Addendum No. ADD-01
Date: June 13, 2022
Project: City of Great Falls
Human Resource Department Tenant Improvement
Architect: Cushing Terrell
219 2nd Avenue South
Great Fall, Montana 59405
To: All Plan Holders of Record
Pages: 7 TOTAL – (3) 8 ½ x 11 and (4) 24 x 36 (If you did not receive correct # of pages, please notify us immediately)

Acknowledge receipt of this Addendum by inserting its number and date in the Proposal Form. Failure to do so may subject Bidder to disqualification. This Addendum forms a part of the Contract Documents. It modifies them as follows:

1 SECOND FLOOR - RENO LIGHTING PLAN
E201 1/4" = 1'-0"

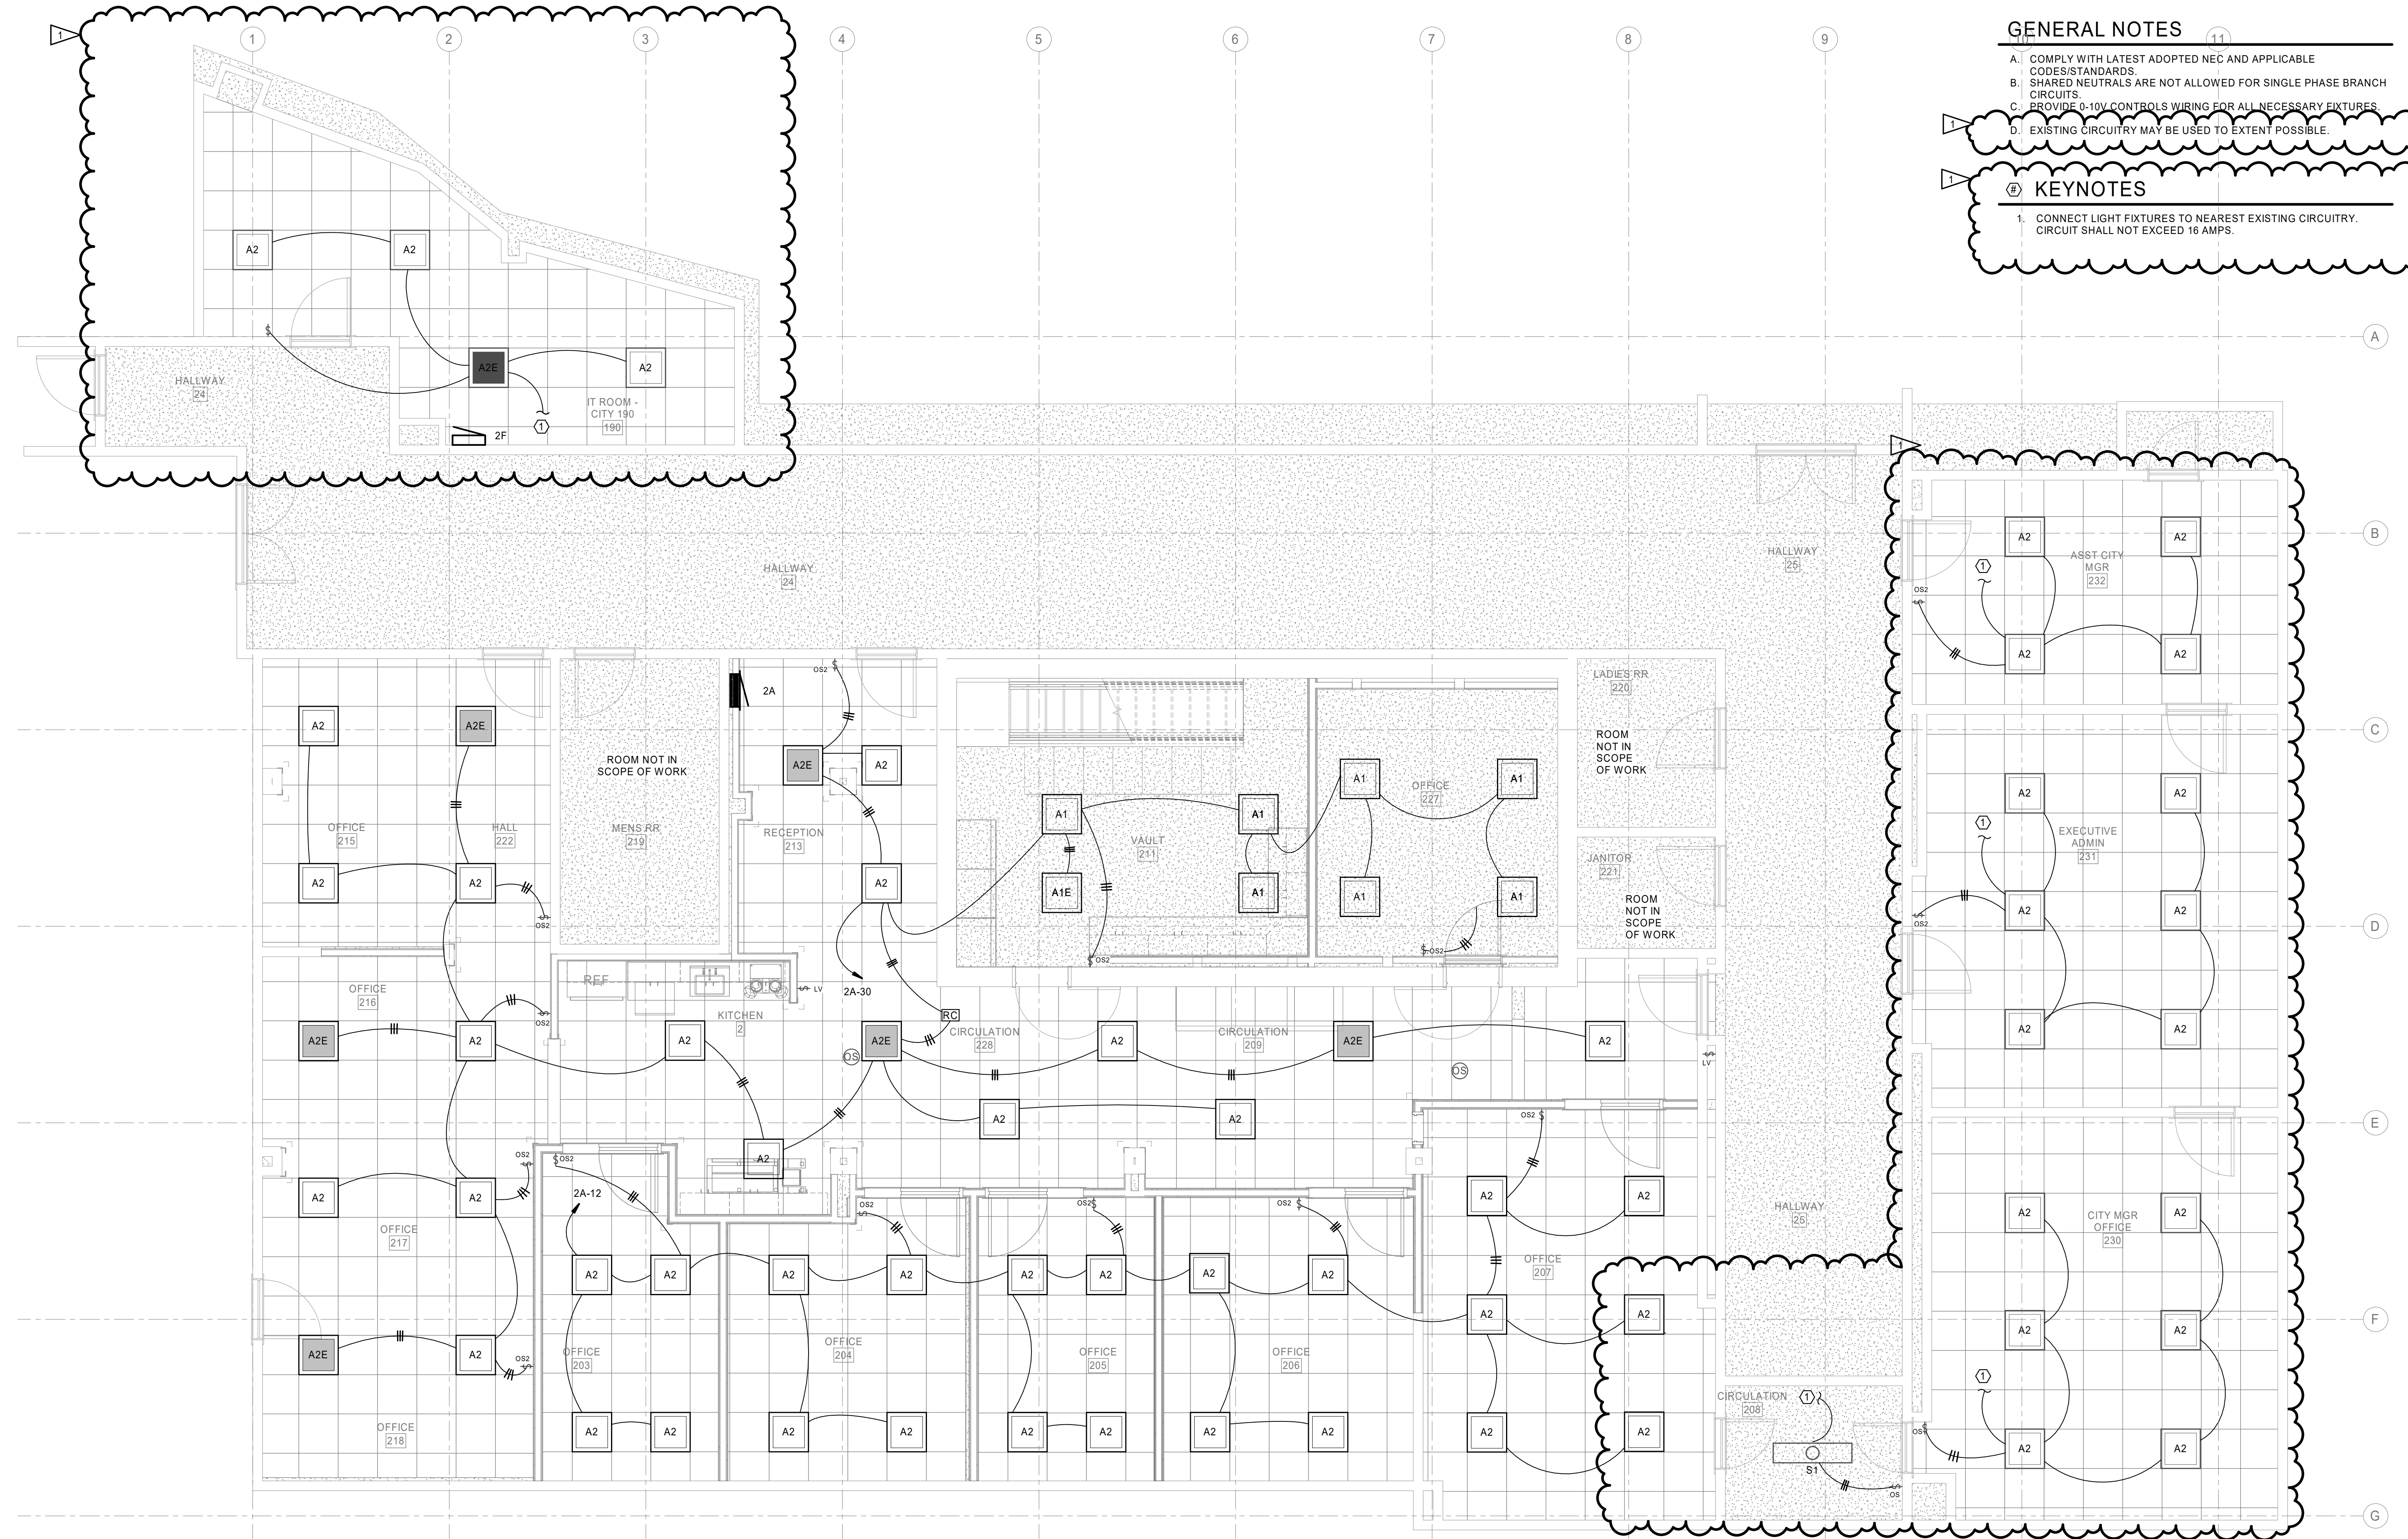
- a. Answer: Yes.
 - b. Electrical plans have been updated accordingly. See below.
12. Question: Electrical plan calls for flush mounted new fixture and new circuit to Pass through room (Circulation 208). Please clarify.

- a. Flush mounted fixture has been modified to hanging. Existing circuit can be reused.
 - b. Plans have been updated accordingly.
13. Question: What gauge steel studs are specified?

- 1. CONNECT LIGHT FIXTURES TO NEAREST EXISTING CIRCUITRY. CIRCUIT SHALL NOT EXCEED 16 AMPS.
